Site Plan Review Committee (SPRC)
Staff Report for:
Crystal Plaza 5 (Site Plan #SPLN20-00015)

Crystal Plaza 5 (Site Plan #SPLN20-00015)
(RPC#s 34-020-003, -017, -018, -265)

SUMMARY: The applicant, JBG Smith, proposes to redevelop the site (“Crystal Plaza 5”) located at 223 23rd Street and 2250 Crystal Drive and construct two new multifamily residential towers with ground floor retail space.

Figure 6: Buildable Envelope and Massing Strategies

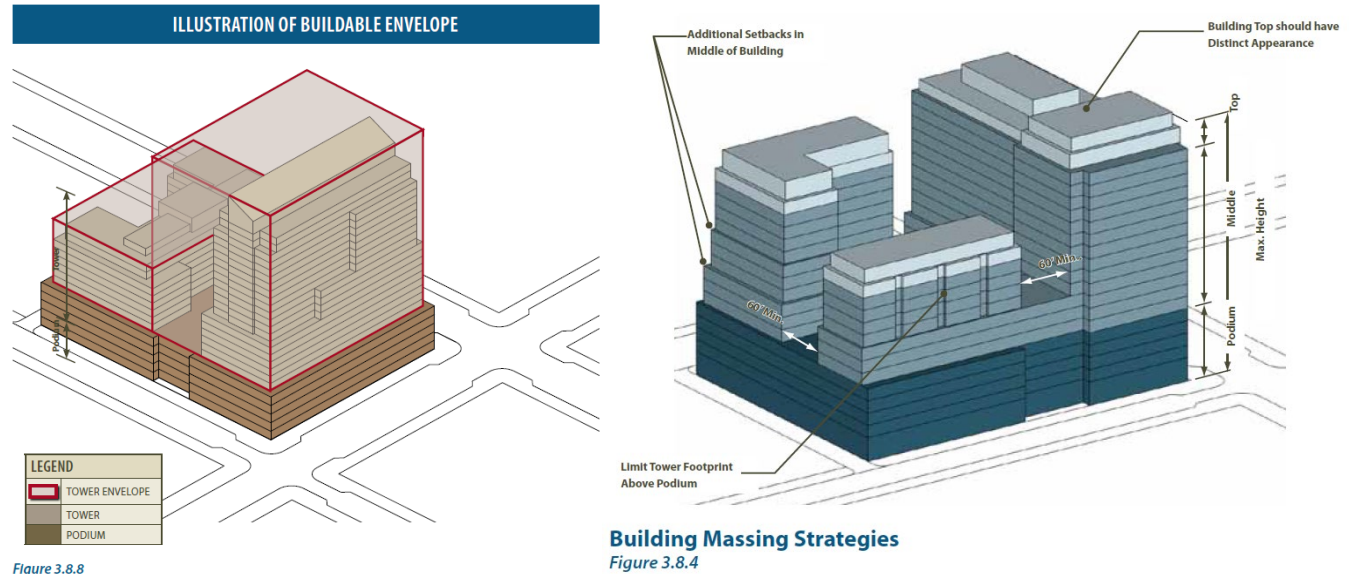
- **Maximum Allowable Height:** As noted above, the combined height of the podium and tower for development of the subject site should not exceed 300 feet except along 23rd Street South where an additional two to three stories of building height may be permitted, and the applicant meets this requirement.

- Towers:
 - Tower Separation: The Sector Plan recommends that towers maintain a minimum separation of 60 feet. The 2250 Crystal Drive Building meets this requirement, while the 223 23rd Street Building does not in this interim phase, until the adjacent Crystal Plaza 6 site can be redeveloped and provide the full 60-foot separation.

- Building Setback Profiles: The Sector Plan recommends two (2) approaches for achieving sculpted buildings with distinct podiums, towers, and tops – a Multiple Setback Approach, and a Single Setback Approach. While the podium should continuously engage the Build-to Line and meet the back of the sidewalk, the tower massing above should taper or step back from the podium along streets and open spaces to achieve aesthetically interesting and attractive buildings, and to allow for light and air between buildings. For building tops, it is generally recommended that the upper two (2) to four (4) floors of all buildings should be no closer than 20 feet from the Build-to Line, unless the proposed design of the building top involves a dramatically creative architectural treatment that is integral to the overall composition of the building. The proposed towers deviate from this guidance in terms of tower massing setbacks, although alternative massing designs with 5-foot step-backs on street frontages have been provided that are in closer alignment with this guideline. However, there is no step-back identified on the west tower façade of the 223 Building, which will be the location of a future Clark-Bell Street alignment. Staff has identified this concern and will continue to evaluate whether these deviations detract from the overall Sector Plan objectives.

- Building Tops:
 - The Sector Plan recommends that a distinctive top, consisting of the upper two to four floors of a tower, should be provided through a change in at least two (2) of the following features - window rhythm, apparent floor height, setbacks, sculpted form, or materials. Staff has identified concerns with both buildings. Specifically, the 223 Building fails to distinguish the top of the central tower element, which currently proposes metal mesh screening of the mechanical penthouse that neither integrates with the overall façade design nor creates a distinctive top feature.

façade. The recommended setbacks are not provided uniformly on either tower; however, the 2250 Building features an enhanced façade treatment consistent with the building tower façade. As noted above, however, the 223 Building does not implement a similar enhanced façade treatment and is therefore not consistent with this guideline.

Figure 8: Public Open Space Map and 23rd Street Plaza Concept

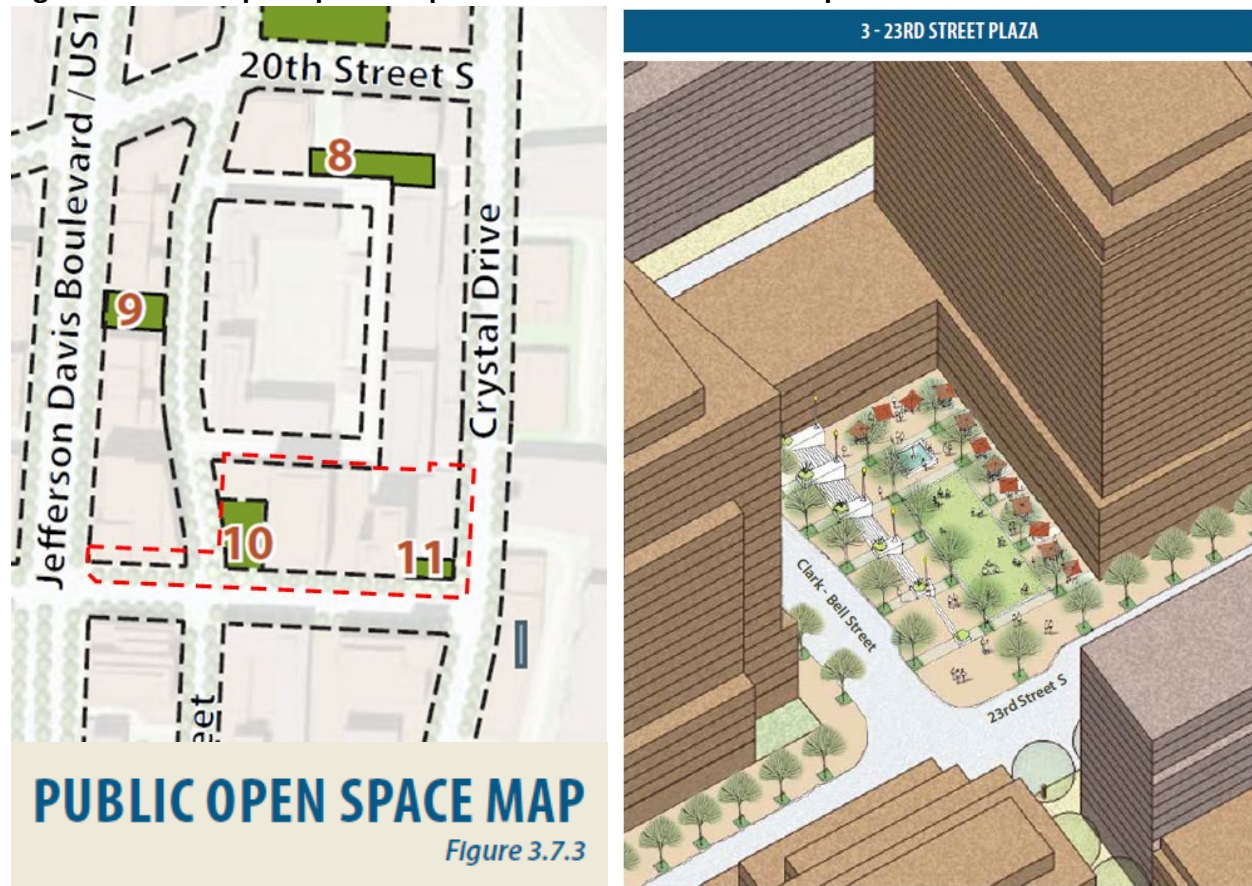
The applicant is proposing a phased Open Space #10 with an initial phase that is 33% smaller than the 13,000 square feet called for in the Sector Plan at 8,670 square feet. This initial phase would be designed and constructed as part of this site plan review, while the final phase would be subject to a future development application of the adjacent Crystal Plaza 6 site and a separate public review process.

The applicant proposes an alternative location for Open Space #11 by creating a public plaza connection to the Underground entrance from Crystal Drive on the north side of the 2250 Crystal Drive Building; however, the total space provided is significantly larger than the 3,300 sf called for in the Sector Plan and the proposed design is consistent with the landscaped plaza referenced in the Sector Plan. This public open space would also be designed and constructed with this site plan development.

Open Space Details: although the full Open Space #10 area will not be achieved with this project alone, staff has recommended that additional design elements be incorporated into the 8,670 sf space that would be delivered with this project. Those include consideration of less intensive landscaping to frame the space and add interest compared to the simple grass lawn area currently proposed. Staff has also identified a need to contemplate pedestrian pathways to both the retail frontage along Open Space #10 and to stairs shown on the northwest side of the site that would provide access to the interior of the block.

Figure 12: 2250 Crystal Drive Building Deviations (Alternative Massing Proposal)

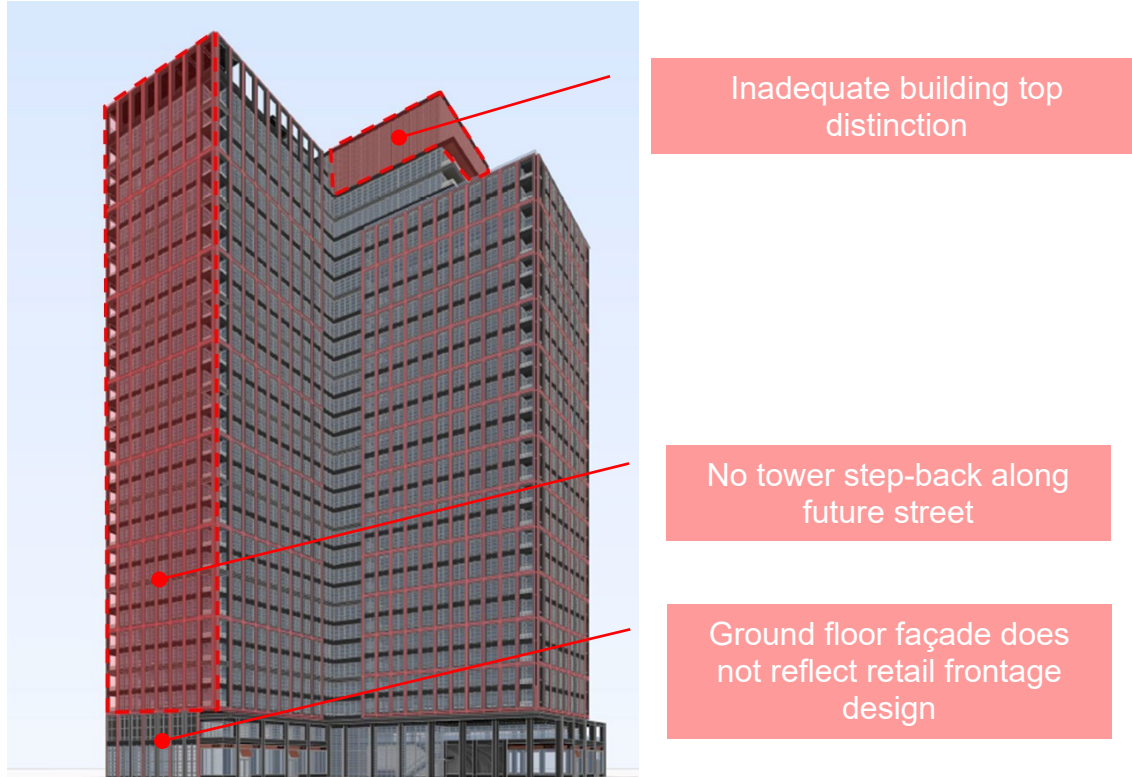
2250 Crystal Drive Building: the current alternative massing design for the 2250 Building, in exchange for implementing tower step-backs along 23rd Street South and Crystal Drive, proposes smaller step-downs in tower mass for tower wings fronting 23rd Street South and an asymmetrical configuration (with four stories added to the southwestern wing and three stories added to the southeastern wing). Although staff believes the original design's step-down

scheme was more consistent with Sector Plan recommendations, staff has identified an issue with the asymmetrical design of this alternative proposal – specifically the top floor of the southwestern wing that now:

- Compromises the building top profile
- Results in inadequate sculpting of the building top
- No longer presents a defined building top through symmetrical contrast with tower floors below
